RE: Potential Oil Seal Leaks with P54, P58, and P59 Pumps

Introduction:

Figure 1: Old Crosshead Design

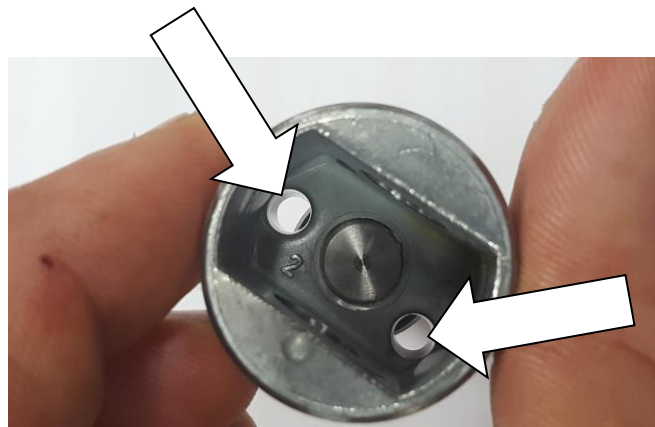
Between 3/23/15 and 12/31/16 the P54, P58, and P59 pumps went through a design change of the crosshead/steel plunger. Prior to this design change the crosshead (Giant Part#: 07777) was two separate parts combined into an assembly. In this case, there were two holes for oil to drain through and return to the pump.

The current crosshead assembly is a single piece, machined out of a steel slug. This part has two milled flat edges and currently does not have the oil return holes. Without these holes pressure is created between the crosshead and the oil seal. Along with this pressure increase, pulsations are created which cause vibration on the plunger oil seal. Which could result in an oil leak.

Previous design with two oil return holes and no milled flats

New design with milled flats and no Oil return holes
